To: INCITS Technical Committee T10

From: Kevin Butt

Document: T10/08-025r0 — Persistent Reservations - Group Exclusive

Figure 1 — Device server interpretation of PREEMPT service action

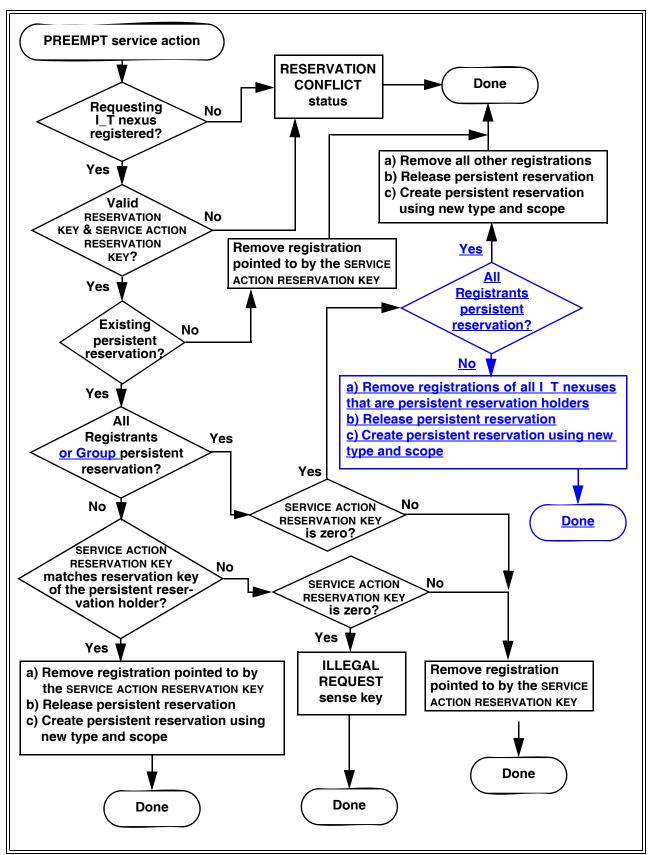
See figure 1 for a description of how a device server interprets a PREEMPT service action to determine its actions (e.g., preempt the persistent reservation, remove registration, or both preempt the persistent reservation and remove registration).
